TO:	Dr. Cone, Superintendent of Schools, LVISD	FROM:	Catherine Blackler <i>Catherine Blackler</i> Senior Project Manager, AGCM
cc:	Belinda Raindl, LVISD	Michael Rogers,	AGCM
RE:	La Vernia ISD – Bond 2023	DATE:	July 17, 2025
SUBJECT:	PR No. 07R	PR DATE:	July 09 2025
PR COST:	\$ 81,645.00	CONTRACTOR:	Bartlett Cocke (RCO 18)

Description	PR#7R - HS Civil Revisions per RFIs 35 & 82	Date	2025-05-14
Status:	Pending Review	Days Impact:	See Below *

Proposal Request

Architect's Project Number: 22075
Proposal Request Number: 7R
Proposal Request Date: July 9, 2025

C4.01

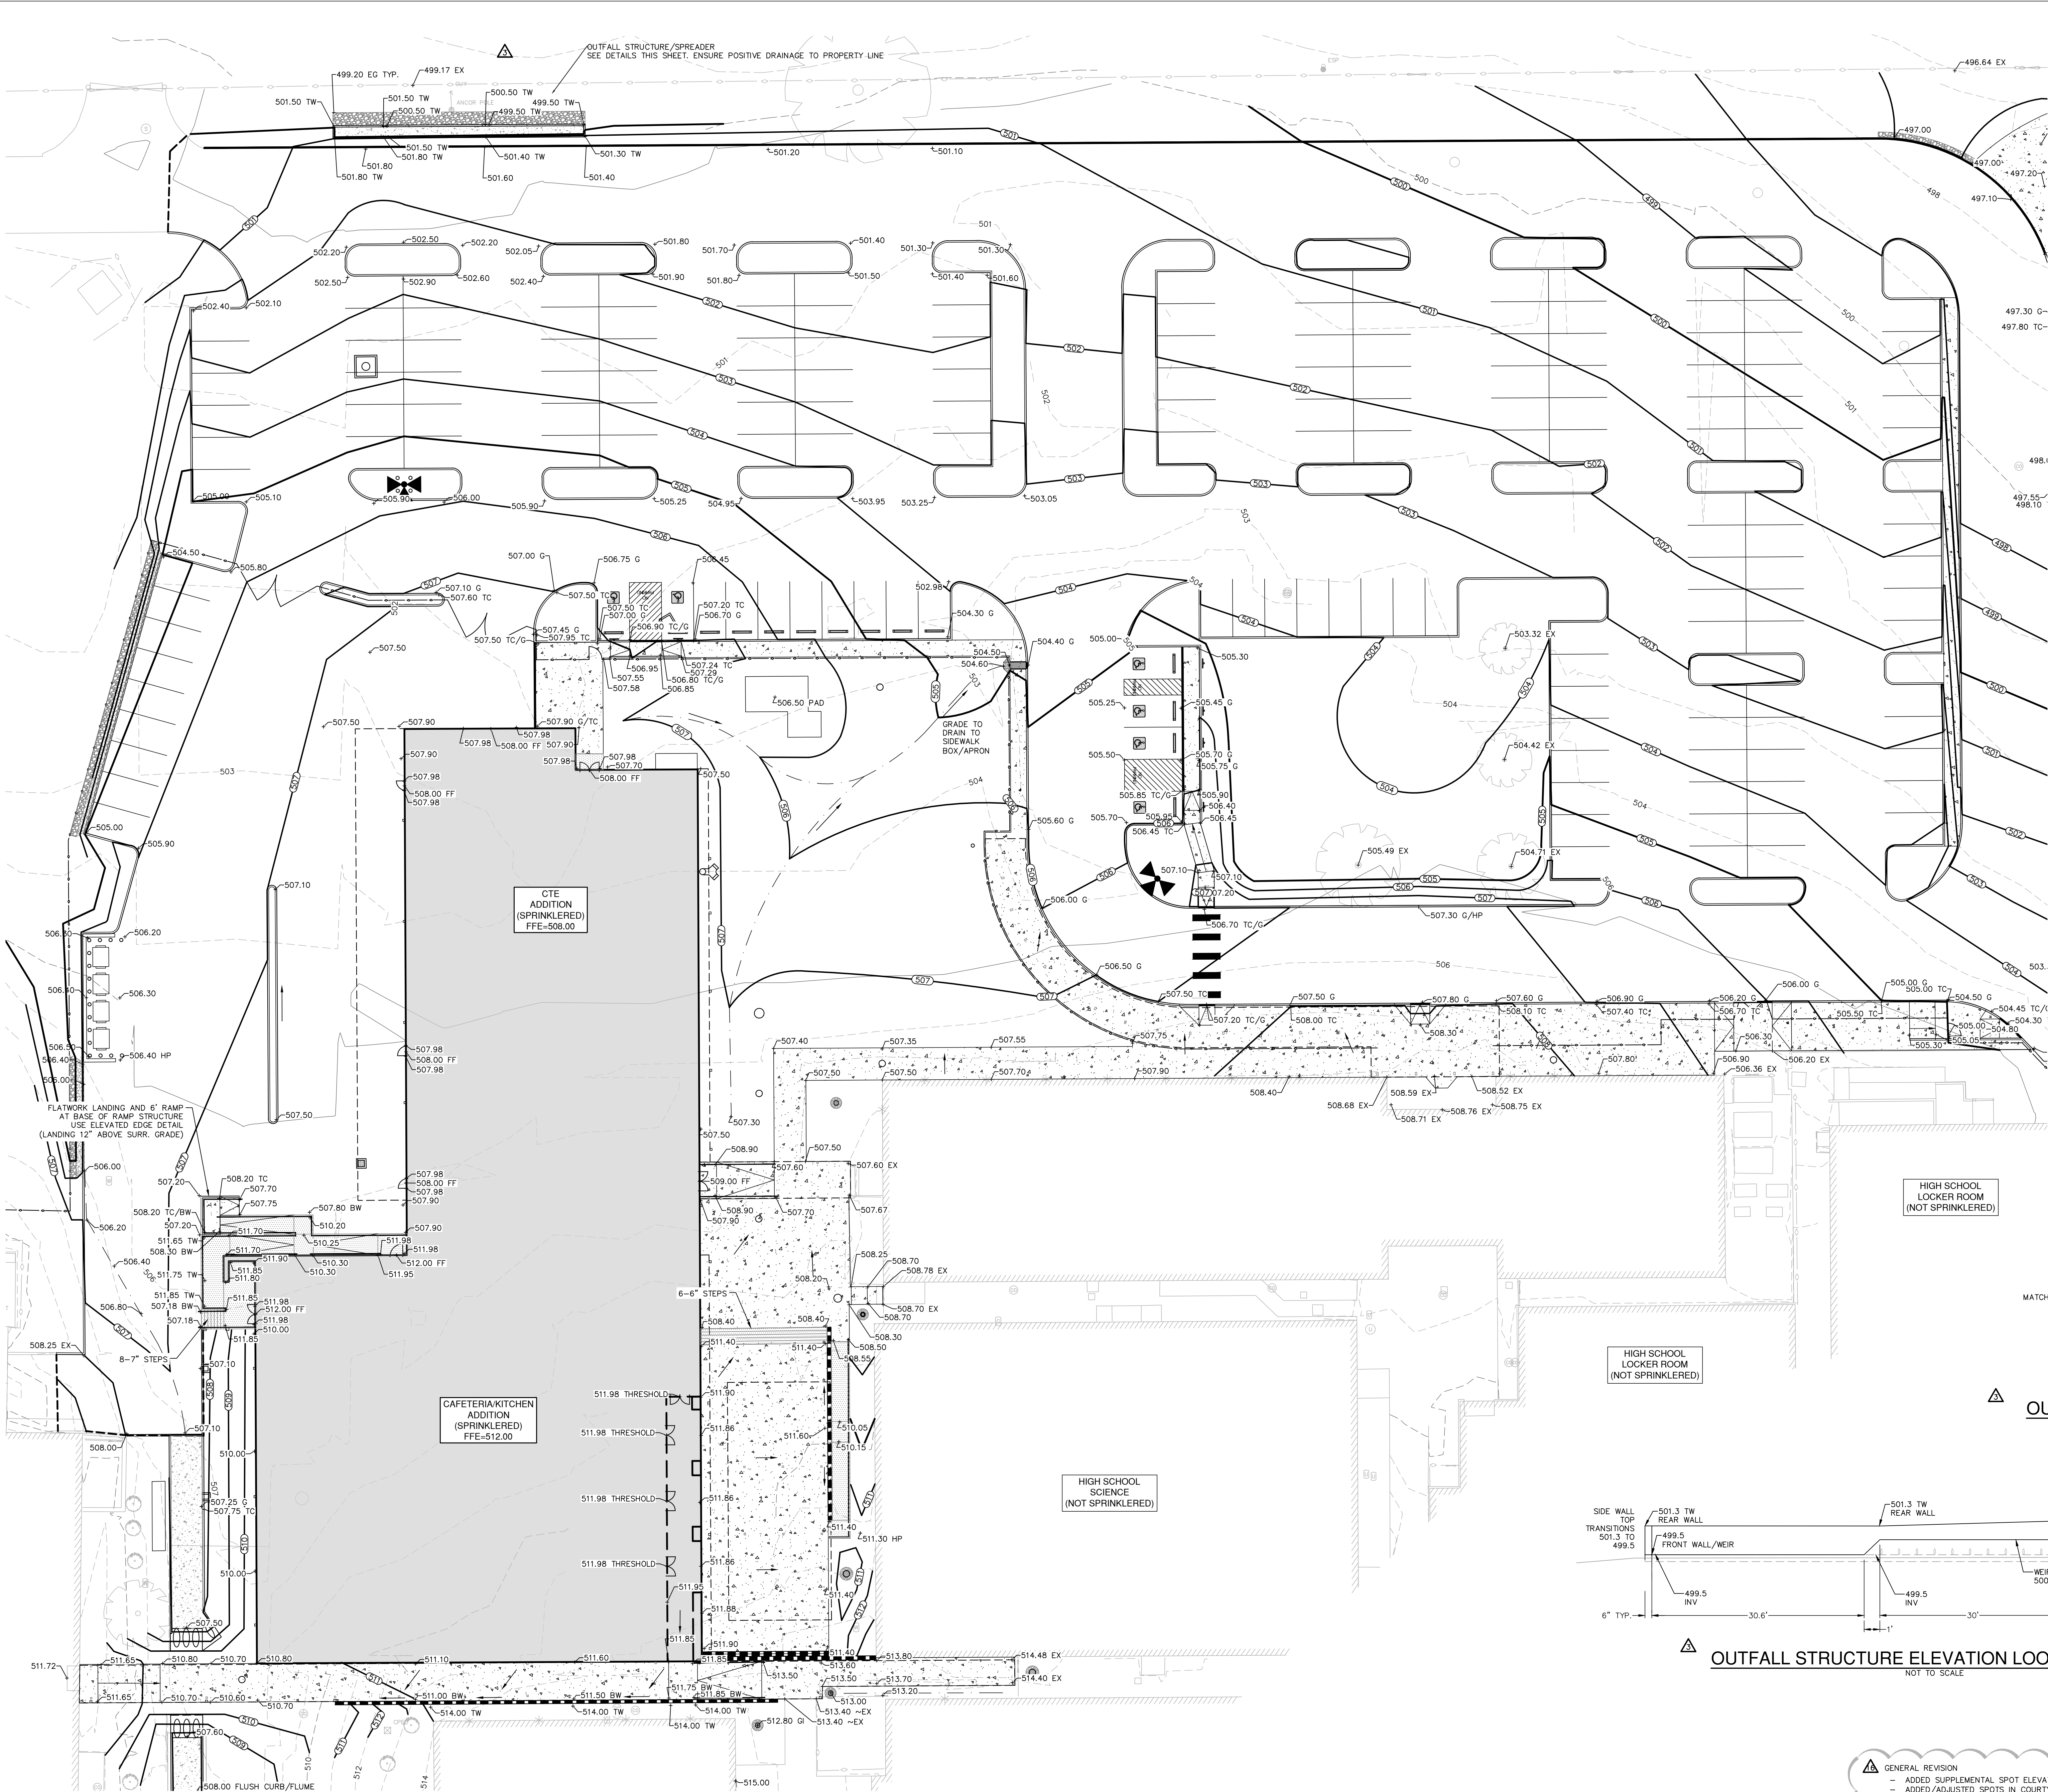
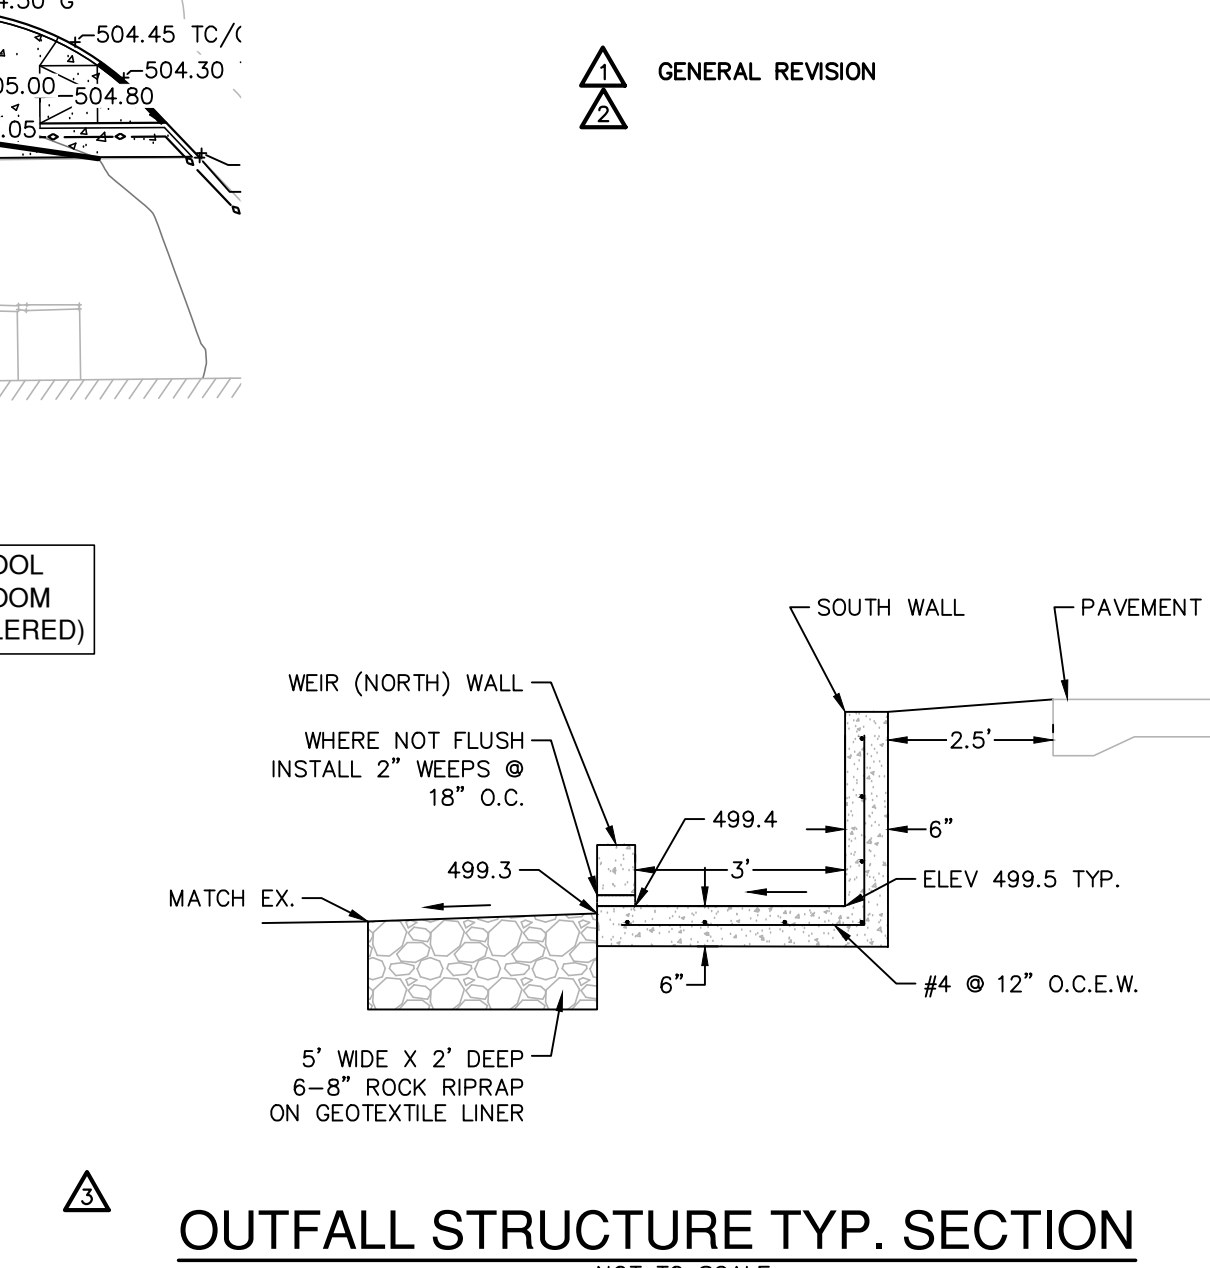
- ADDED SUPPLEMENTAL SPOT ELEVATION
- ADDED/ADJUSTED SPOTS IN COURTYARD AREA
- GRADE TO DRAIN AROUND TRANSFORMER TO NEW SIDEWALK BOX/APRON

C5.00

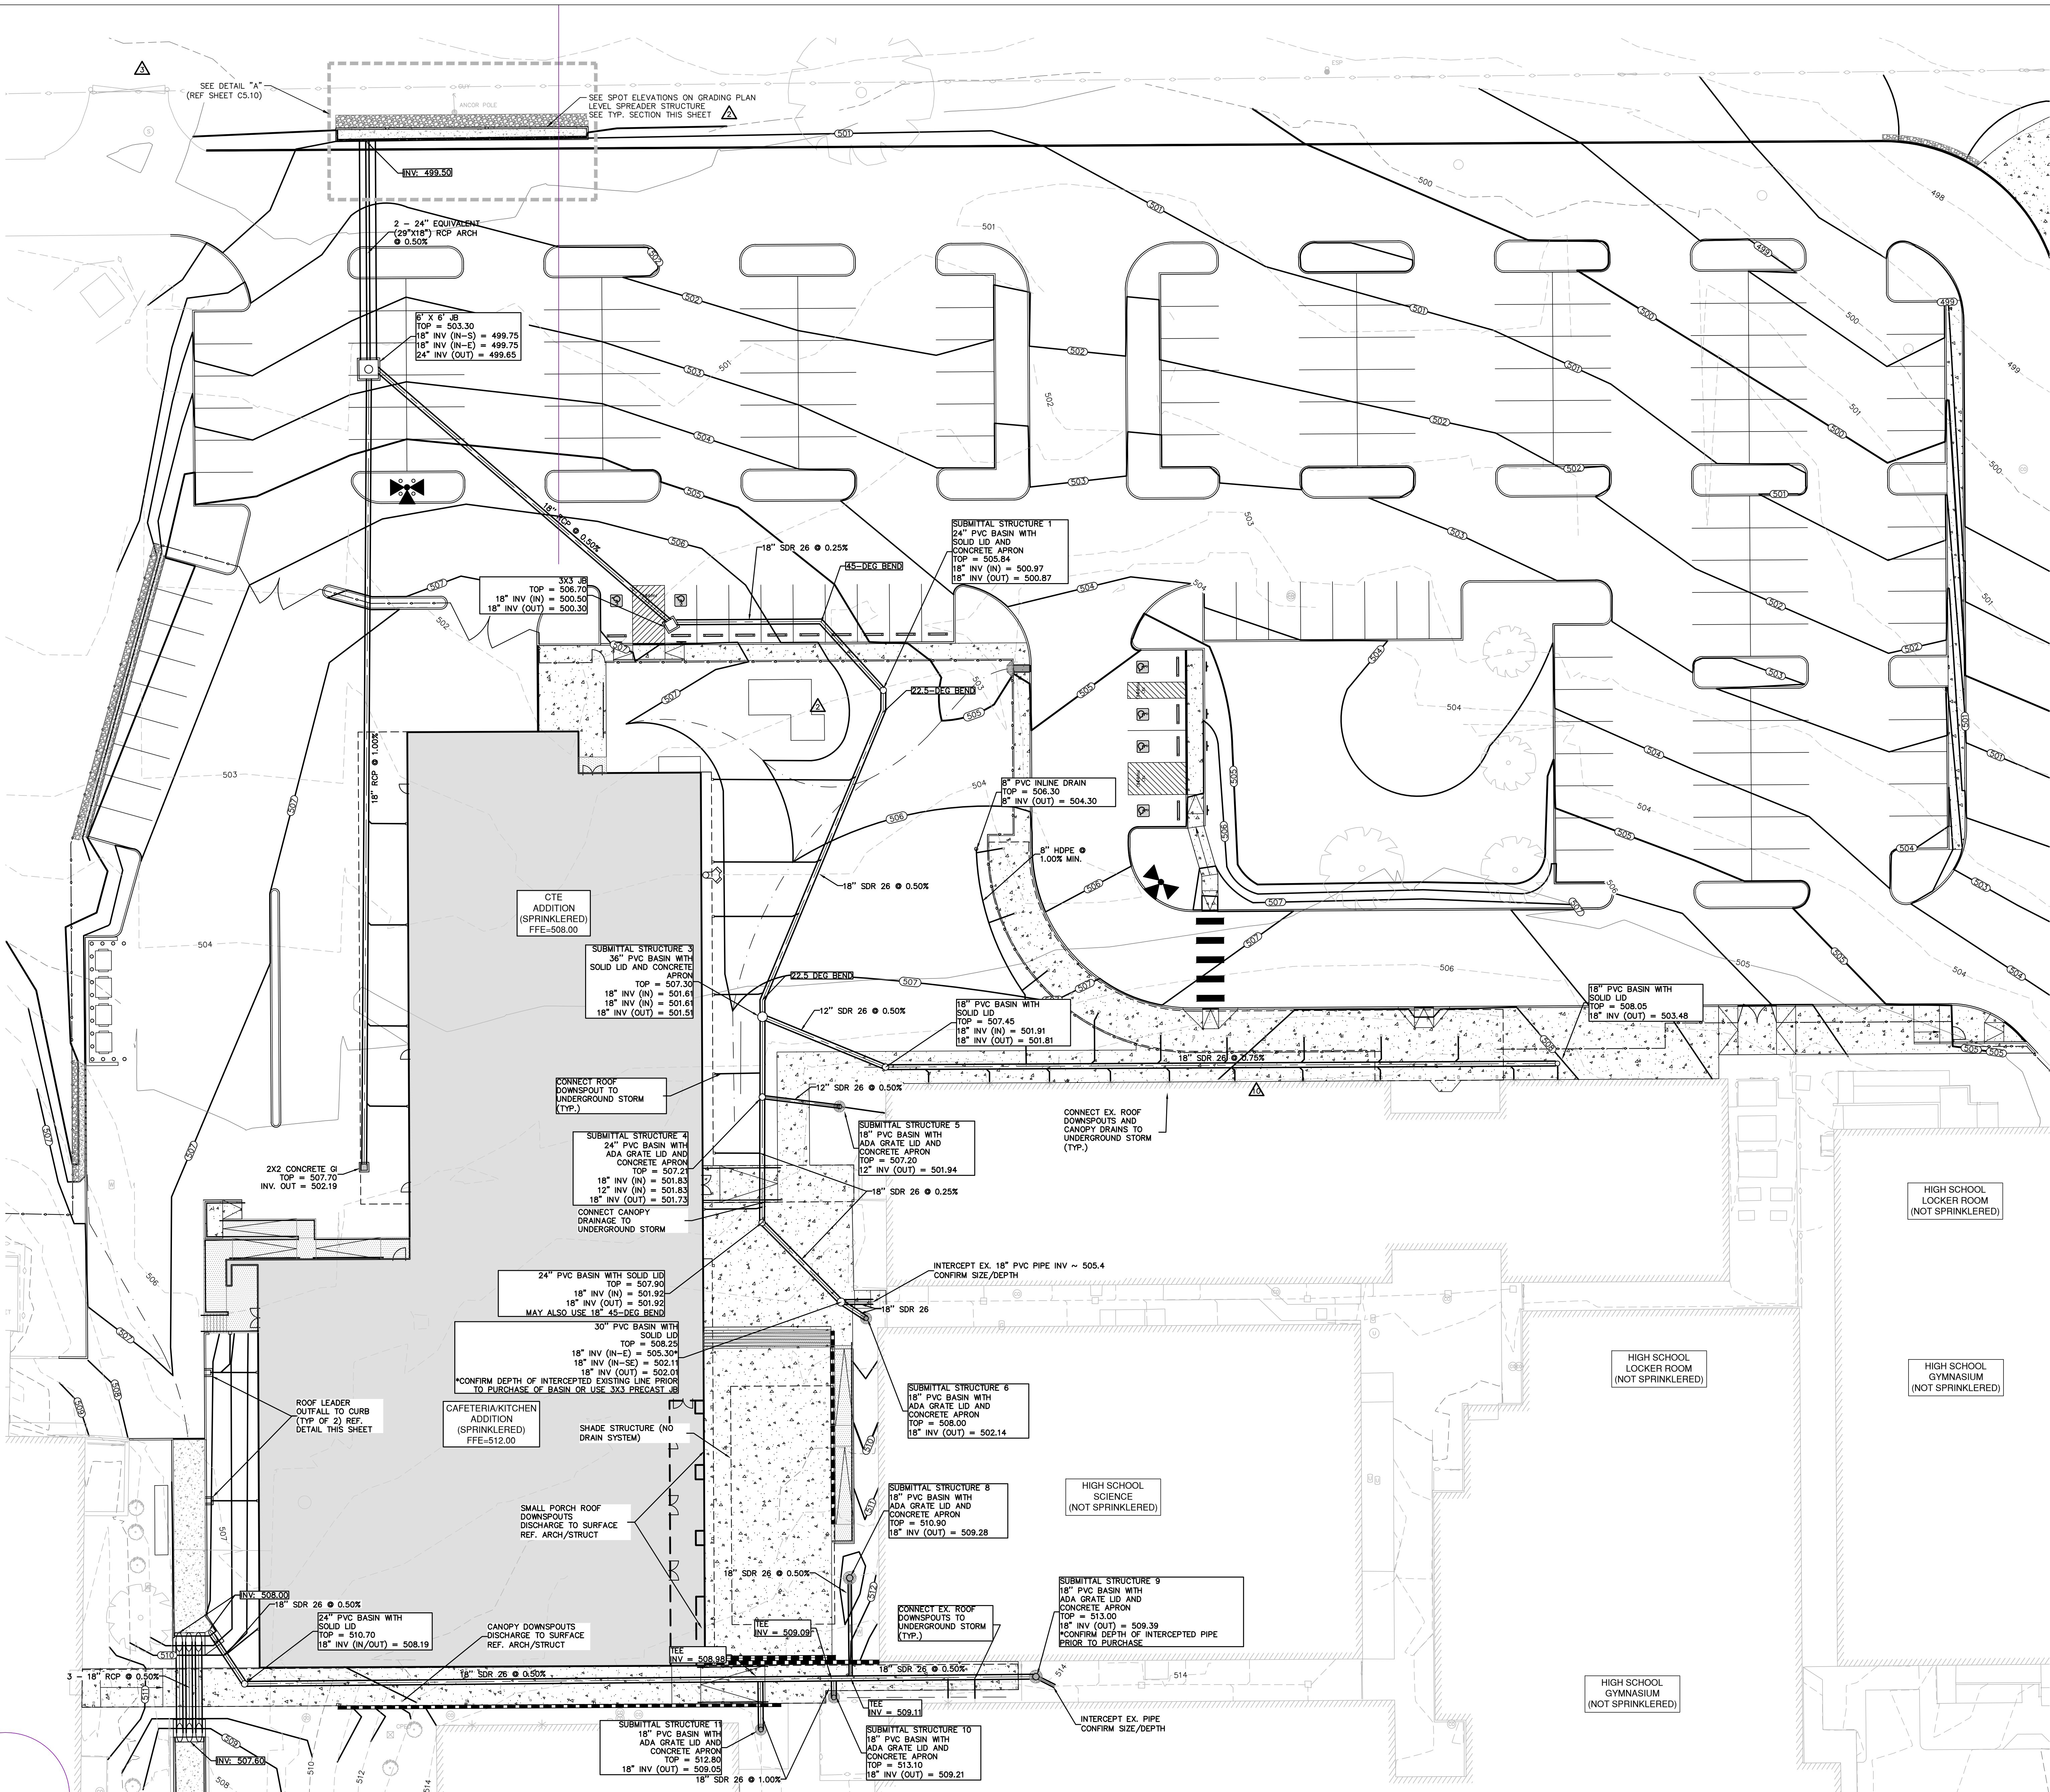
Provide an **itemized cost proposal** to incorporate the required civil grading and drainage revisions necessary to revert to the original contract scope. This proposal should reflect adjustments needed to integrate materials and work that were already purchased or completed ahead of time under the prior revised scope.
